Application Serial No. 10/594,308 -7-Attorney Docket No. 0756-7836

Amendments to the Drawings:

REMARKS

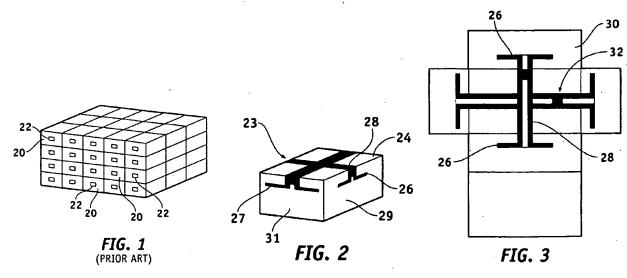
The Official Action asserts that Bridgelall teaches "a package (20, Fig. 1) for packing a product provided with a semiconductor device (RFID tags) (22, Fig. 1)" (page 3, Paper No. 20081006). The Applicant respectfully disagrees and traverses the assertions in the Official Action.

Figure 1 of Bridgelall (reproduced below, at left) is prior art to Bridgelall and appears to disclose that an RFID is provided with each container. That is, Figure 1 does not teach or suggest a product with a semiconductor device, and a package for the product provided with a resonance circuit.

Further, Figure 2 of Bridgelall (reproduced above, at center) appears to disclose a container 24, an RFID relay device 23 on the container 24, where the RFID relay device 23 includes antennas 26 and 27, transmission line 28 and RFID tags 32 (see Figure 3, reproduced above, at right). Although Bridgelall discloses, for example, bottles 42 of fluid (e.g. beverages) (¶ 28; see Figure 5, reproduced below), Bridgelall does not teach or suggest that the bottles 42 could or should be provided with semiconductor devices or RFIDs.

Rather, it appears that Bridgelall teaches an RFID <u>relay</u> device 23 where a signal is received by an antenna and transmitted through antennas, for example, on two

different sidewalls of the container, and the signal may be transmitted to an RFID tag (¶ 27). However, Bridgelall does not teach or suggest a package for packing a product, where the product is provided with a semiconductor device and where the package is provided with a resonance circuit; or that a semiconductor device is attached to a product, that the product is contained in a package, and that a resonance circuit is attached to the package.
